# REGIONAL REVIEW FINDING

ARC REVIEW CODE: R605251

**Submitting Local Government:** City of Atlanta  
**Name of Proposal:** Northeast Atlanta Beltline

Preliminary Report:	May 25, 2006	<b>DEVELOPMENT OF REGIONAL IMPACT REVIEW REPORT</b>	Project:	Northeast Atlanta Beltline #1058
Final Report Due:	June 24, 2006		Comments Due By:	June 8, 2006

NorthEast Atlanta Beltline DRI # 1058

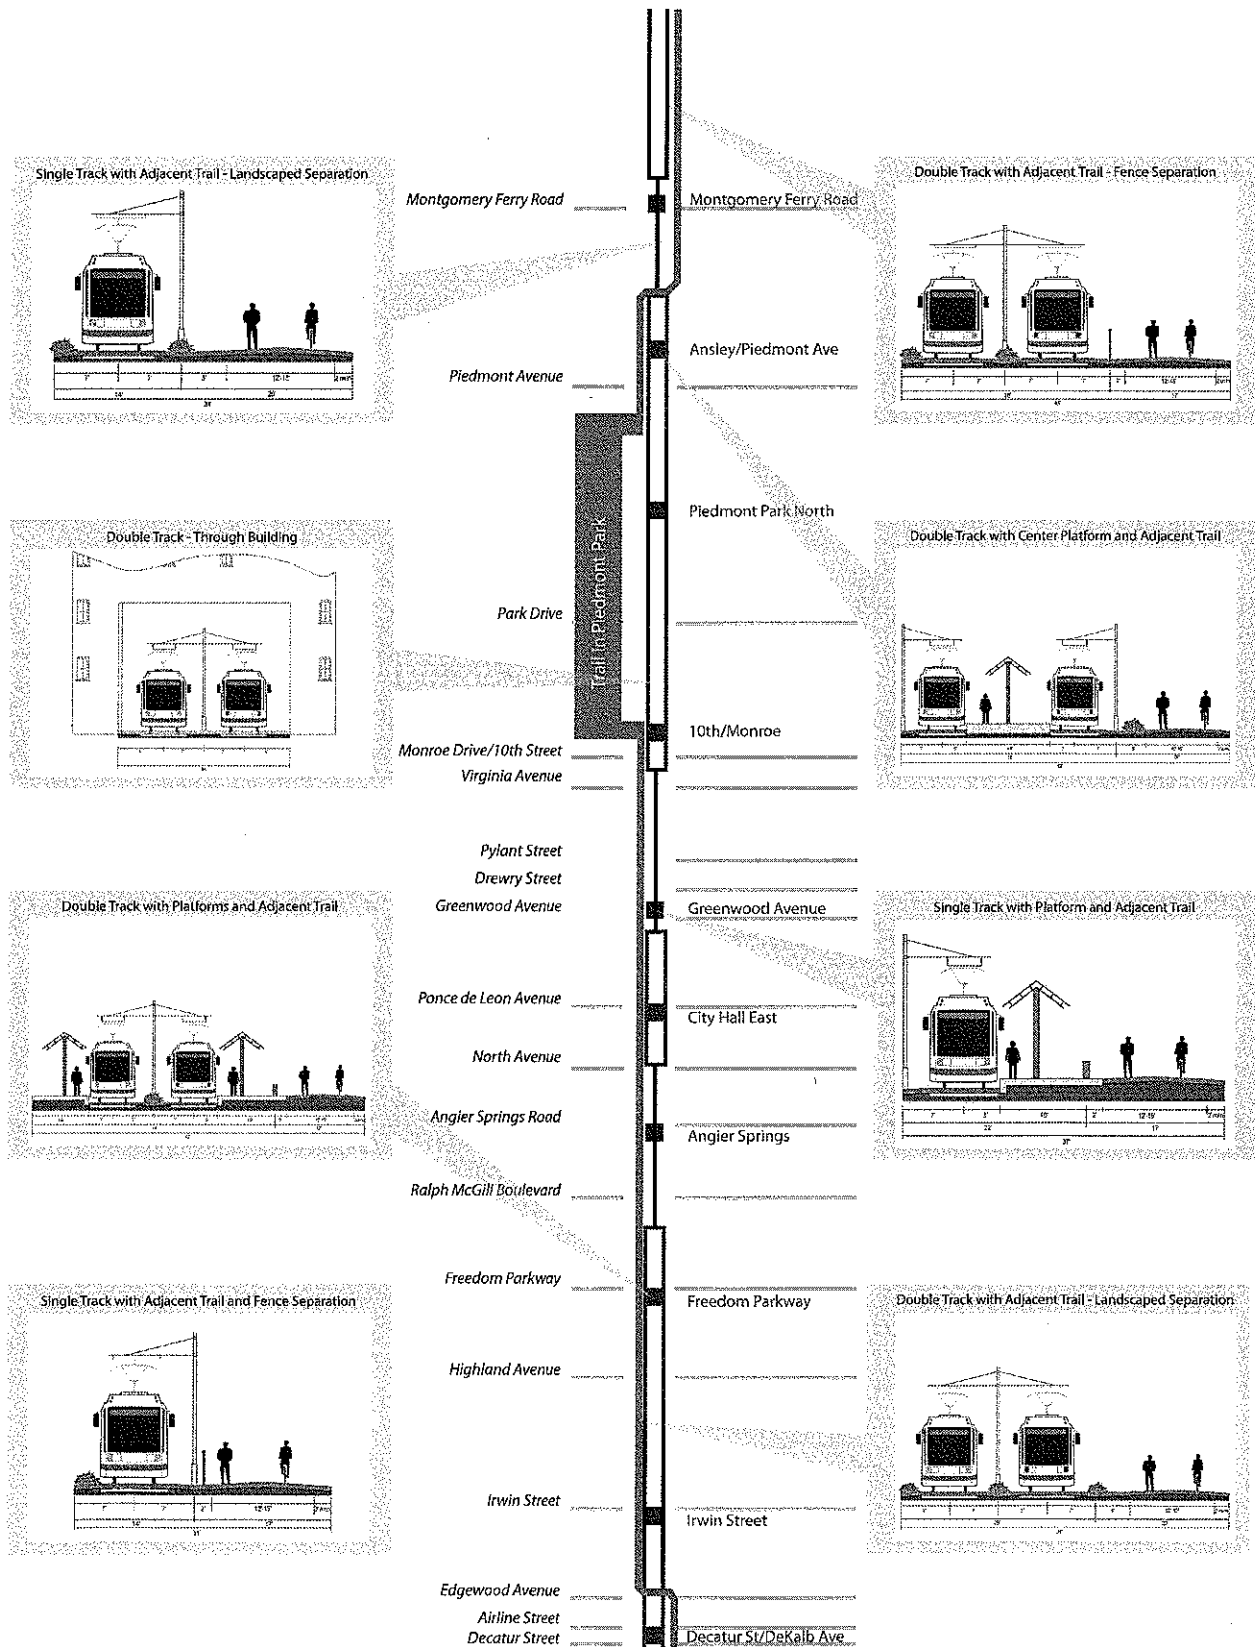
As indicated the project sponsor has reserved a continuous transit / trail corridor of almost 20 acres through the project. This land will be transferred via an appropriate mechanism to a public or non-profit entity as determined at zoning. Until a receiving organization is identified and zoning is approved, it is impossible to define the terms and mechanism for transference. The project sponsor has no plans to establish a transit system.

As noted above, the concept plan includes reservation of 18 acres for public greenspace and new parks. As with the land set aside for transit, this land will be transferred via an appropriate mechanism to a public or non-profit entity as determined at zoning. Until a receiving organization is identified and zoning is approved, it is impossible to define the terms and mechanism for transference. The project sponsor has no plans to construct or maintain the public parks.
